Access Audit Site Reports

Atlanta State Park

Accessibility Evaluation

Inspection Date: 04/05/2022

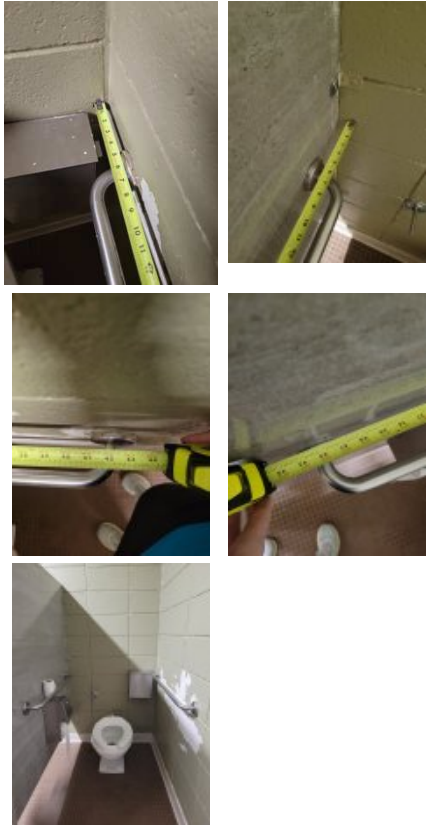
Finding Number	Area Description	Lat/Long	Finding	As Built	Recommendation	Citation	Photos	Figure
186	White Oak Camping Area: White Oak - Men's Restroom	[33.2341261 , -94.2352704]	There are no accessible bathing or shower facilities. Where facilities for bathing are provided for the public, clients or employees, including showers or bathtubs, at least one shower or bathtub and support facilities such as lockers, and not less than 1 percent of all facilities, shall be accessible.	shower lacks accessible features	Create an accessible shower in locker/bathing room.	2015 ABAAS Section: F213.3.6 2012 TAS Section: 213.3.6 2010 ADAS Section: 213.3.6		
187	White Oak Camping Area: White Oak - Women's Restroom	[33.2340868 , -94.2352865]	Coat hooks provided within the room shall be located within one of the reach ranges specified in 308. Shelves shall be 40 inches (1015 mm) minimum and 48 inches (1220 mm) maximum above the finish floor or ground. Where coat hooks or shelves are provided in dressing, fitting or locker rooms without individual compartments, at least one of each type shall comply with 803.5. Where coat hooks or shelves are provided in individual compartments at least one of each type complying with 803.5 shall be provided in individual compartments in dressing, fitting, or locker rooms required to comply with 222.1.	hook 67" AFF	Lower hook to max 48" AFF.	2015 ABAAS Section: 308.2.1, 308.1, F222.2, 803.5 2012 TAS Section: 308.2.1, 308.1, 222.2, 803.5 2010 ADAS Section: 308.2.1, 308.1, 222.2, 803.5

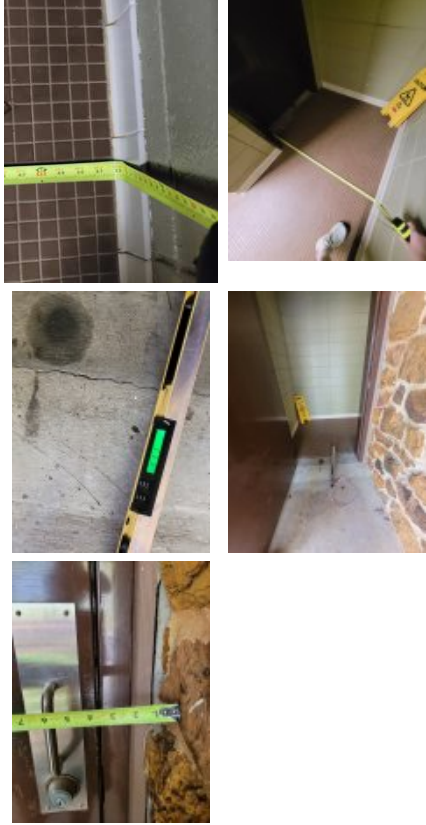
Finding Number	Area Description	Lat/Long	Finding	As Built	Recommendation	Citation	Photos	Figure
190	White Oak Camping Area: White Oak - Women's Restroom	[33.2341261 , -94.2352718]	The restroom sign does not comply with one or more applicable requirements for the location, height, and properties of the sign.	Non compliant sign, non compliant location	Acquire and mount signage, including Braille, raised lettering and access symbol mounted on wall, latch side of door, 48" to baseline of lowest character and 60" to baseline of highest character	2015 ABAAS Section: F216.2, 703.1, 703.2, 703.5, 703.6 2012 TAS Section: 216.2, 703.1, 703.2, 703.5, 703.6 2010 ADAS Section: 216.2, 703.1, 703.2, 703.5, 703.6		
191	White Oak Camping Area: White Oak - Women's Restroom	[33.2341305 , -94.2352798]	The mirror is mounted too high. Mirrors must have the bottom edge of the reflecting surface a maximum of 40 inches above the floor if above a sink or counter. Mirrors not located above lavatories or countertops shall be installed with the bottom edge of the reflecting surface 35 inches maximum above the finish floor or ground.	Both mirrors at 42" AFF	Lower at least one mirror so reflective surface is max 40" AFF	2015 ABAAS Section: 603.3 2012 TAS Section: 603.3 2010 ADAS Section: 603.3
